ATTACHMENT 1

1) Rationale behind submission

A. Consistency with Chatswood CBD strategy

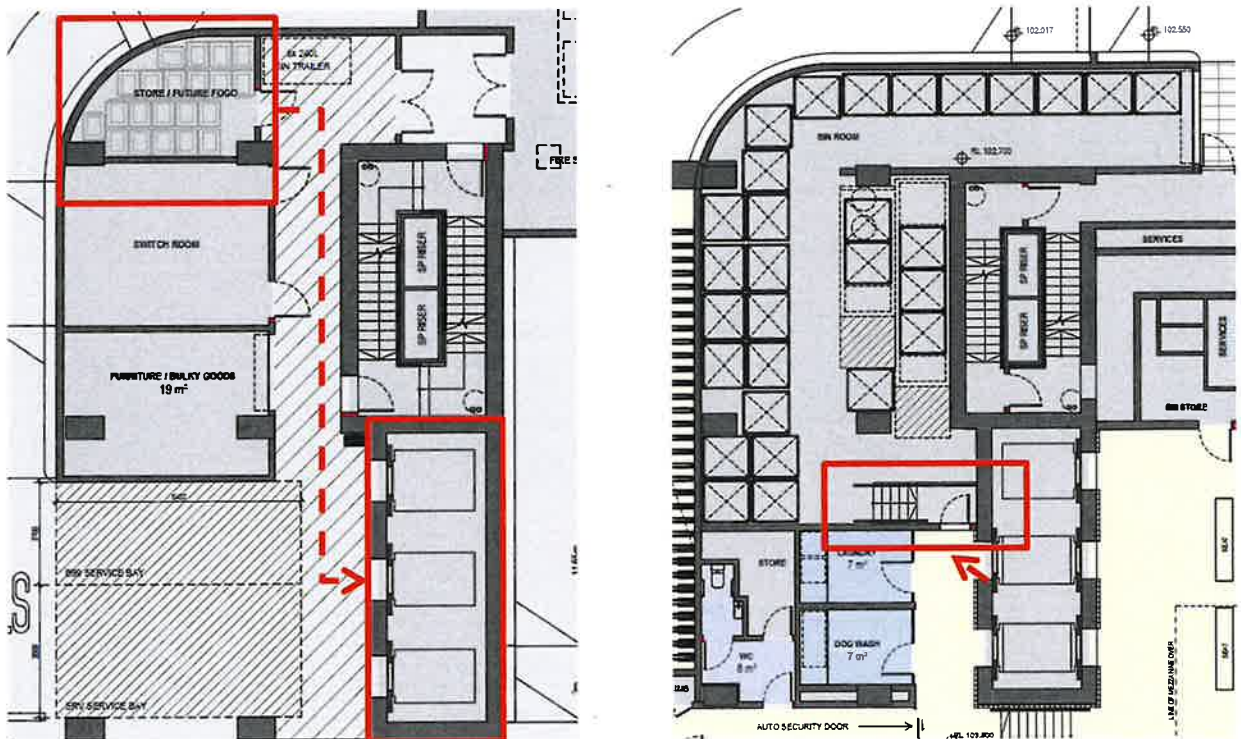
In the current proposal, the FOGO bin room is on the B1 Level, while waste collection is proposed to take place from Ground Level.

The OWMP and architectural plans do not indicate the FOGO bin carting route from the B1 Level to Ground Level. It appears that the caretakers must use residential lifts to cart the bins as there is no back-of-house lift. There also appear to be obstacles (i.e., steps and doors) in the route to cart FOGO bins to the Ground Level bin room for collection or the bins must be carted through the residential lobby. The figures below highlight these issues.

The waste space provided for the retail tenancy does not appear to be practical, due to the small size. There is only space for two 1,100L bins, stacked very closely together, back-to-back, without any manoeuvring space (see Figure 1). This suggests that for staff to place items correctly in the waste or recycling bin, one of the bins would need to be removed from the room before the bin at the back could be used. It is not realistic to expect staff to move the bulk bins every time waste is disposed, and this is likely to result in unrecovered recyclables in the waste bin or contamination in the recycling bin.

The location of the FOGO bin room should be re-considered so that it is in a suitable location for servicing. If caretakers are still required to cart the FOGO bins, the bin carting route for caretakers should meet the following requirements:

Council's view is that the application should be amended to provide a retail waste room of a sufficient size to allow the bins to be placed so that staff can use them easily, and do not have to move them frequently.
